**ADDENDUM NO. 2**

**CHICOPEE**  
**Federal-Aid Project No. HIP(NGB)-3912(004)X**  
**Bridge Replacement, C-13-038, I-391 over (ST 116) Chicopee Street**  
**Design-Build**

**Questions and Responses**

**RFI Subject:** Phase Line Temporary SOE Constructability in BTC Configuration

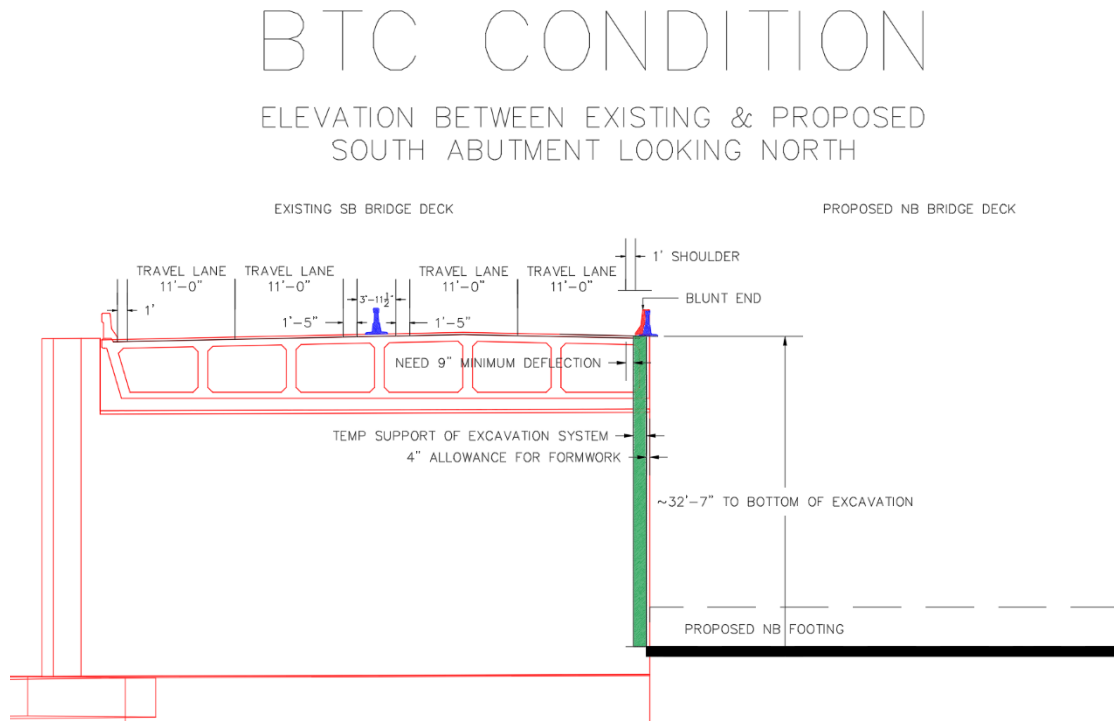
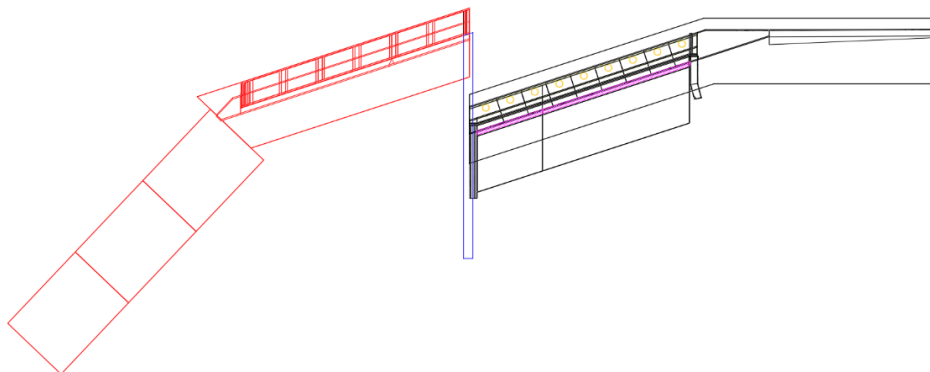
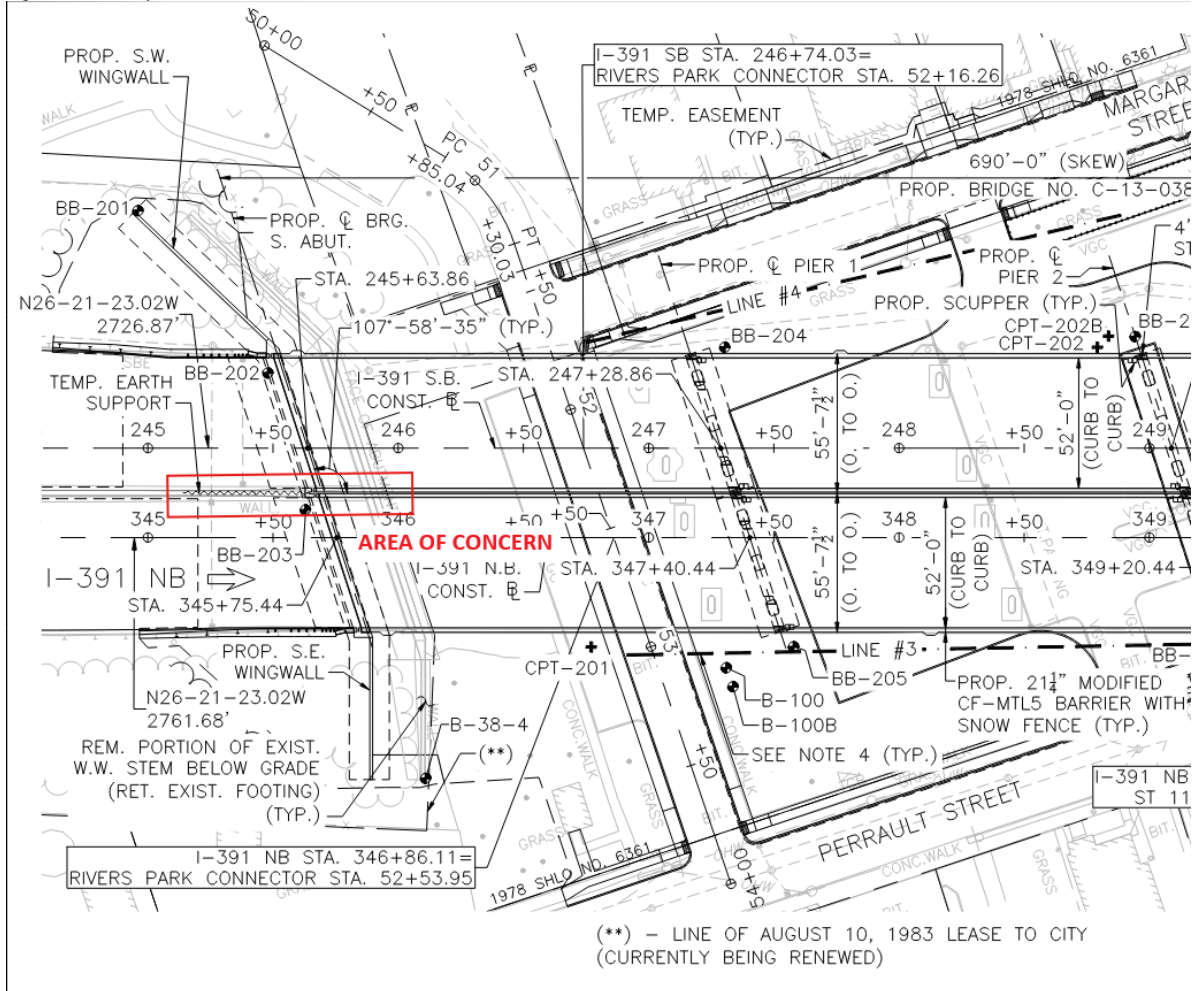
Question 3) RFI regarding the constructability of the phase line temporary support of excavation at the south abutment. Please let us know if any additional details are required.

The proximity of the existing and proposed bridge and the location of the phase line shown in the BTC configuration at the south abutment does not appear to allow enough space for construction of a safe temporary support of excavation system.

The lane configuration shown in the BTC does not allow enough space for the installation of temporary barrier with deflection and temporary earth support system to enable construction of the phase 1 abutment to the extents shown.

We do not believe this is constructable as shown in the BTC.

Response 3) *This response will be provided in a future addendum. (A-2)*
